E5071C-13A

S E R V I C E N O T E

E5071C – ENA Series Network Analyzer, 9 kHz to 20 GHz

Step Attenuator Replacement Procedure

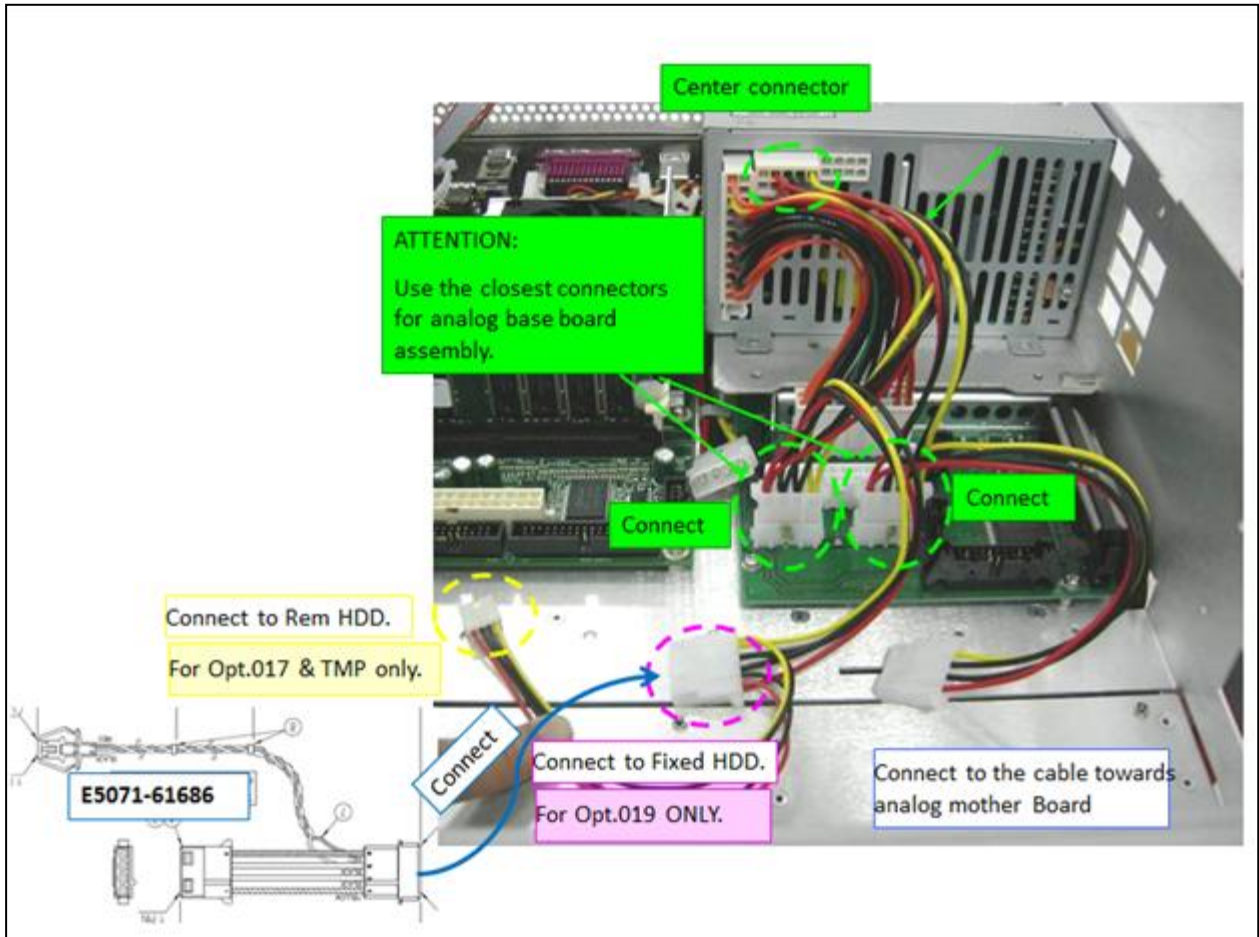
3. Cable assembly **E5071-61665** is replaced by **E5071-61685** and **E5071-61686**. **E5071-61686** will be the newly added channel power supply to attenuator.

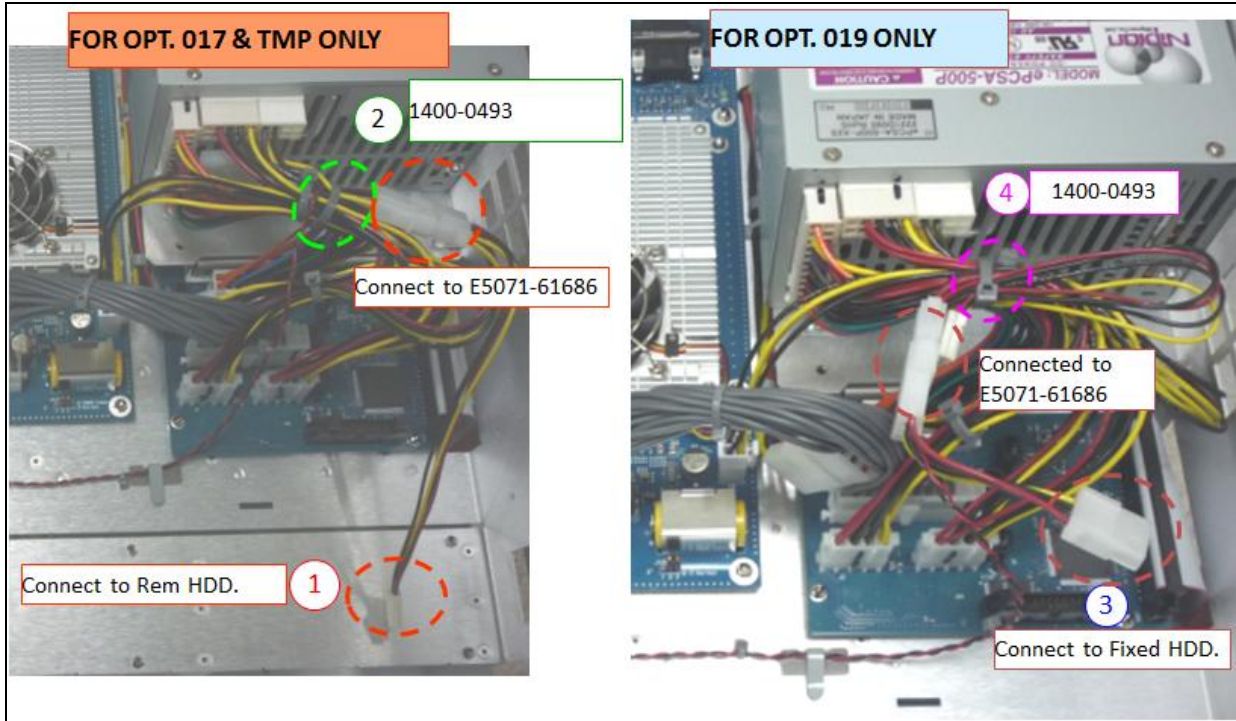
Step 1. Connect the cable assembly to the power supply connector as shown below.

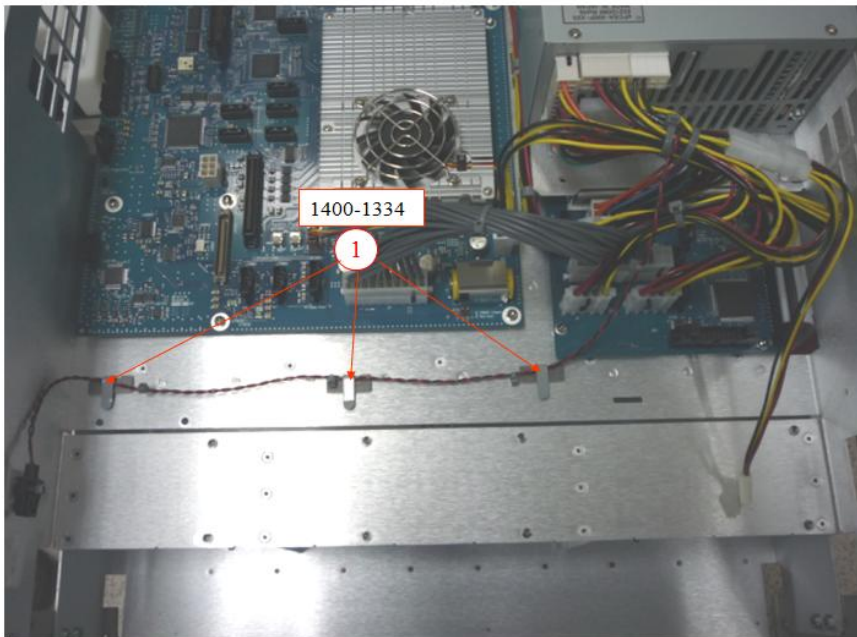
Step 2. Connect one end of the cable assembly to the HDD power connector according to unit options.

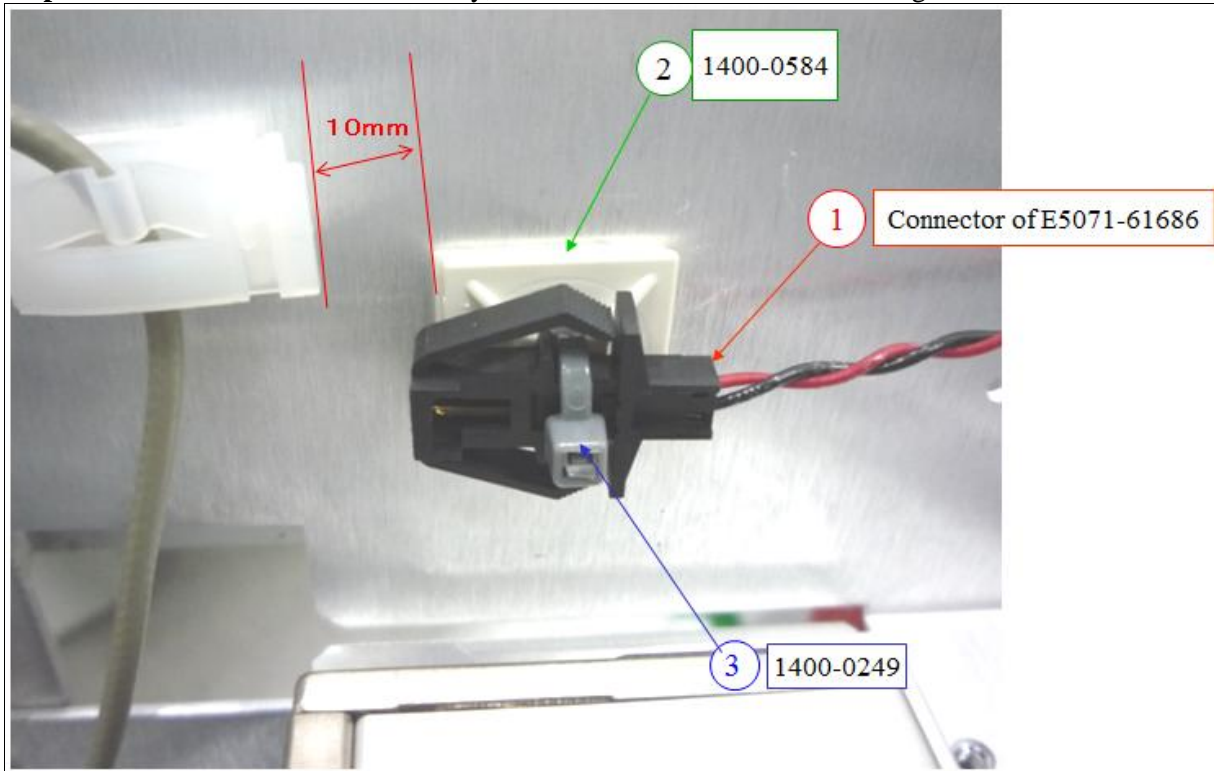
Step 3. Properly install the cable assembly in place with cable clamp as shown.

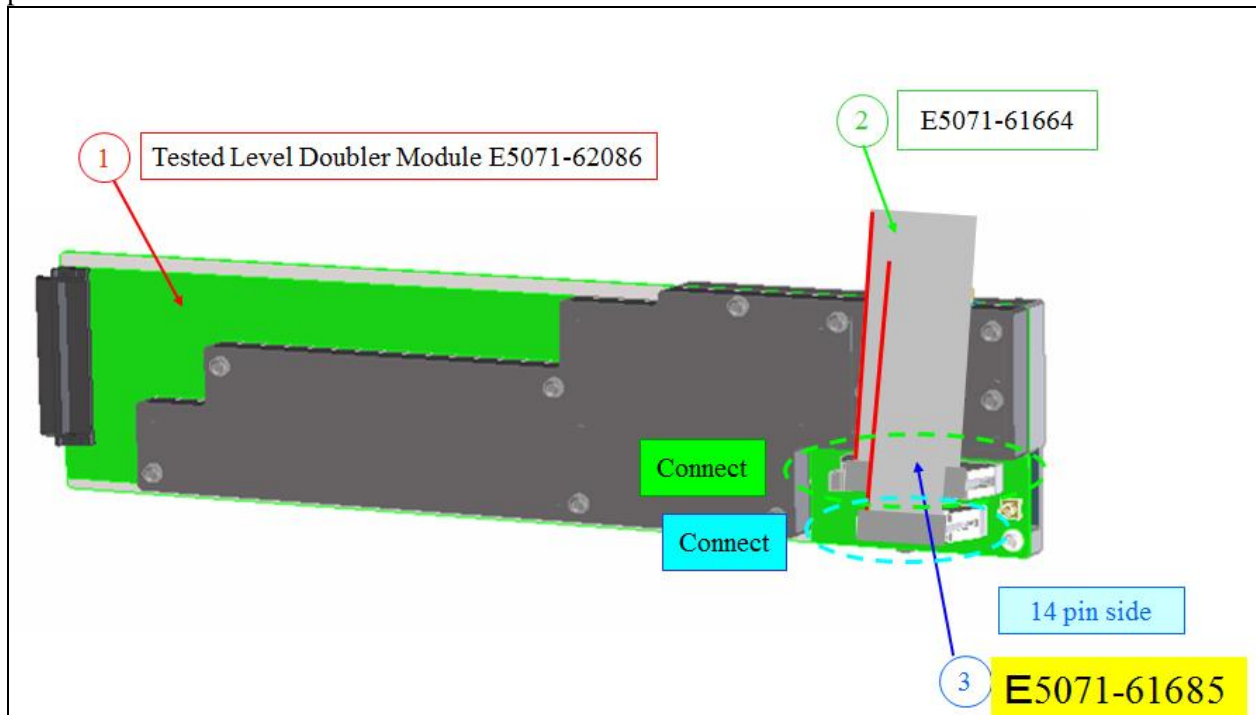
Step 4. On the end of the cable assembly, mount the connector as shown in figure below.

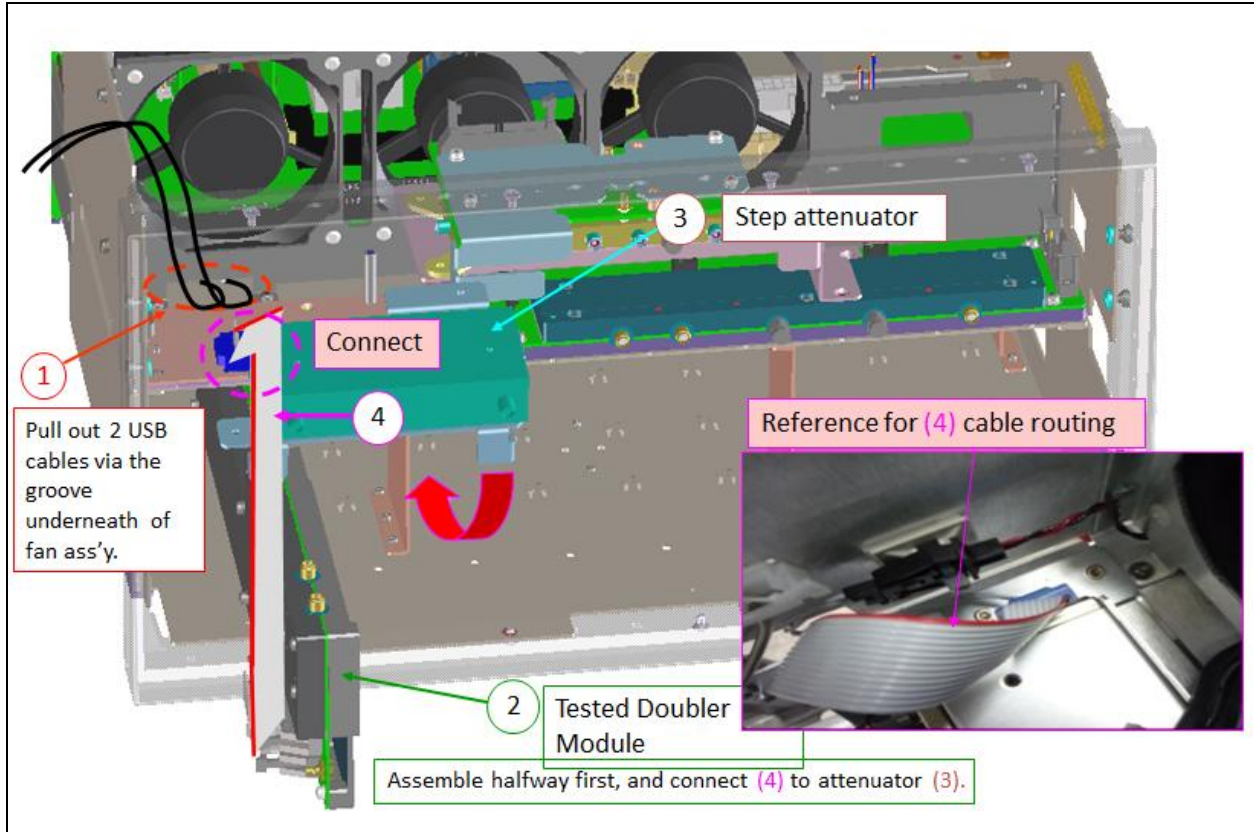
Step 5. Connect the cable assembly E5071-61685 to Tested Doubler Module as shown. Reuse the previous E5071-61664.

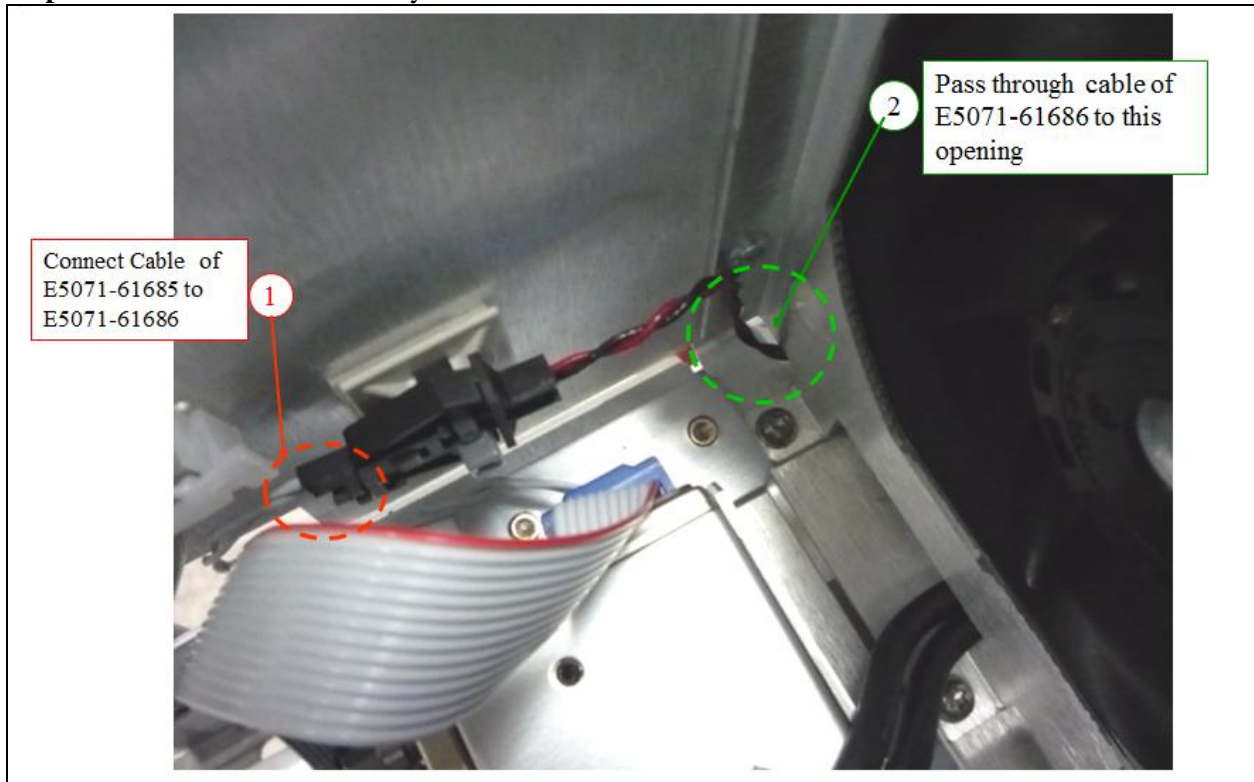
Step 6. Install the tested Doubler Module followed by the Step Attenuator.
